TO: Mercedes-Benz Dealer Principals, General Managers, Sales Managers, Service Managers, Parts Managers	FROM: Gregory Gunther, Senior Manager, Vehicle Compliance and Analysis, Engineering Services
RE: <b>Recall Campaign Launch Notification</b> <b>Replace Fuel Pump Delivery Module – Wave 3</b> <b>MY21-24 C-Class, E-Class, S-Class, SL, GT, GLC, GLE, GLS and G-Class (205/206, 213/238, 223, 232, 290, 253/254, 167 and 463 platforms)</b>	DATE: June 14, 2024

Campaign No. 2024010011, April 2024

Revision C: 06/14/2024

## **Replace Fuel Pump Delivery Module – Wave 3**

**Figure 2**

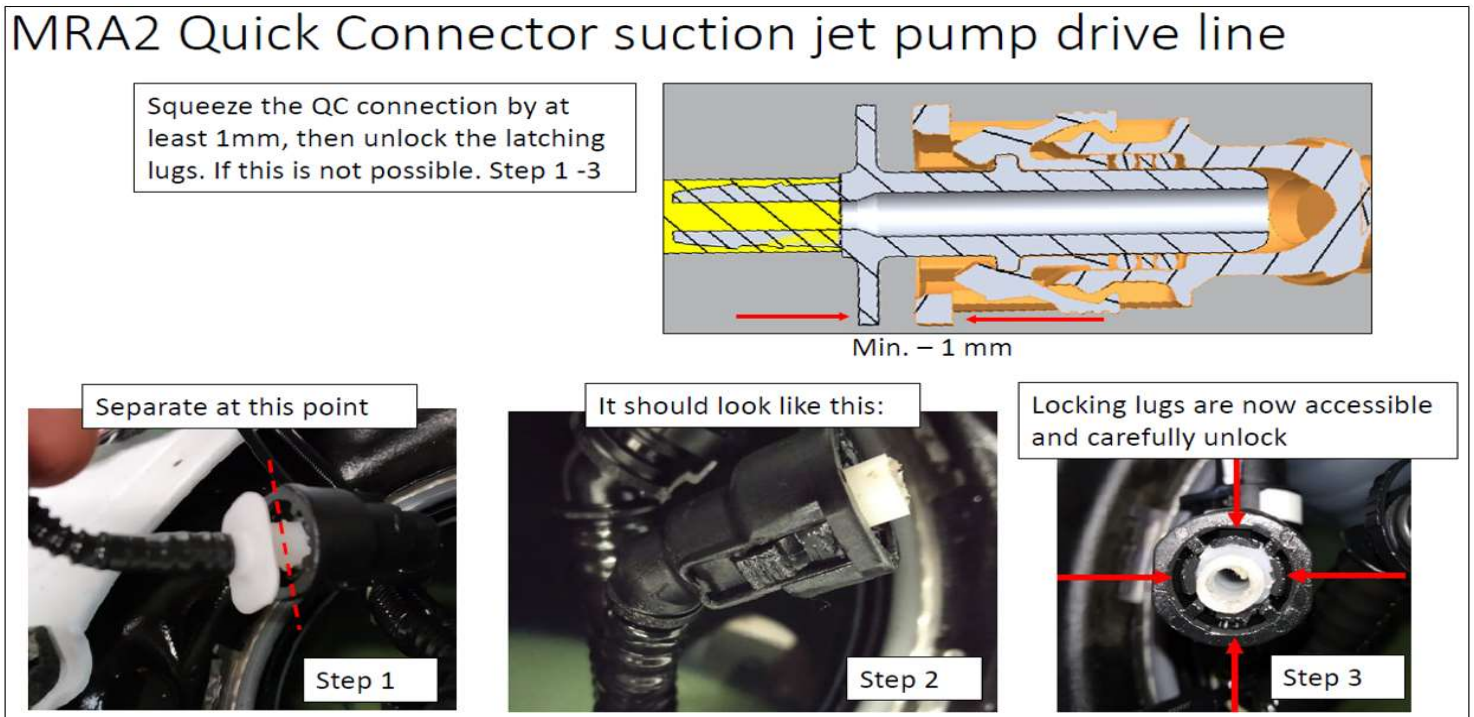
**i** **Only model 206, 232:** Note on disassembly of suction jet pump drive line quick connector.

The procedure steps 1-3 should only be performed when the quick disconnect is not working (**Figure 2**).

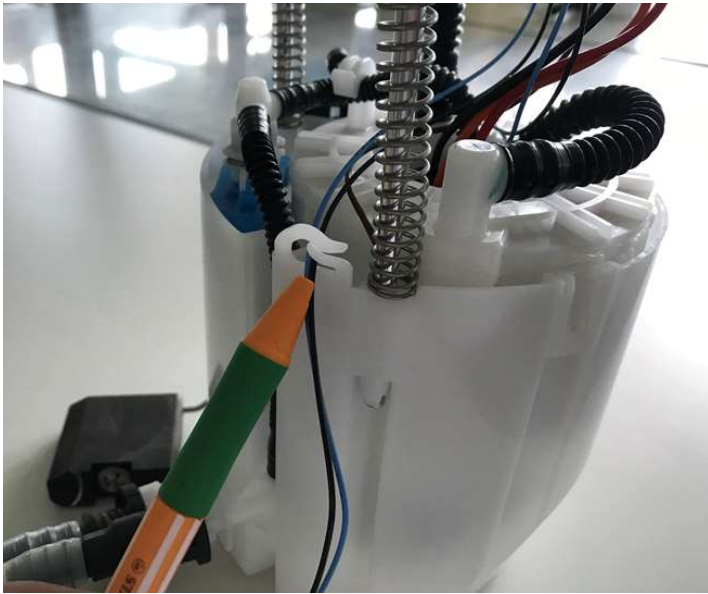
**i** **Only for model 167**

Contrary to the WIS document (**AR88.60-P-2001ME - Remove/install tank filler recess**), the tank filler recess must **not** be removed. Disconnecting the hose lines at the activated charcoal canister and the sealing bellows on the inside at the tank filler recess is sufficient.

**Figure 3**

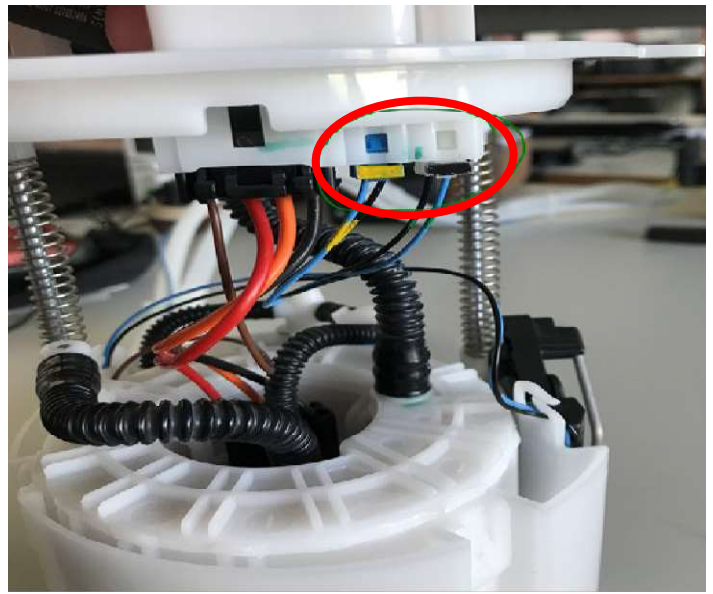
**i** For **all** vehicles with code 228 stationary heater, the connection for the fuel supply system must be cut off before installing the fuel pump (**Figure 3**).

**Figure 5** (release corresponding connector and disconnect the contacts)

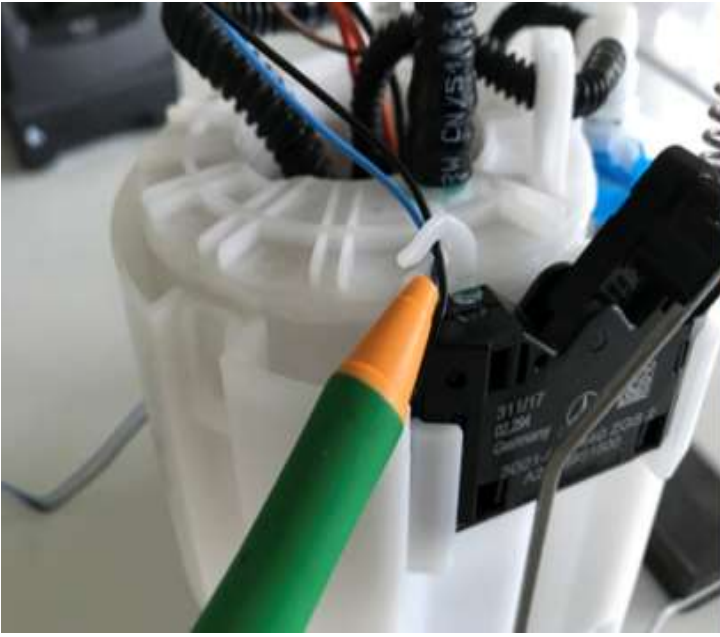
**i** Delivery modules that are delivered **without float-and-lever sensor** must be modified. (**Figure 4-7**)

**Figure 4** (remove electric lines from routing clip)

**Figure 6** (remove lines from routing clip)

**Figure 7** (using a screwdriver, carefully push float-and-lever sensor housing away from module housing and at the same time push float-and-lever sensor housing upwards.)
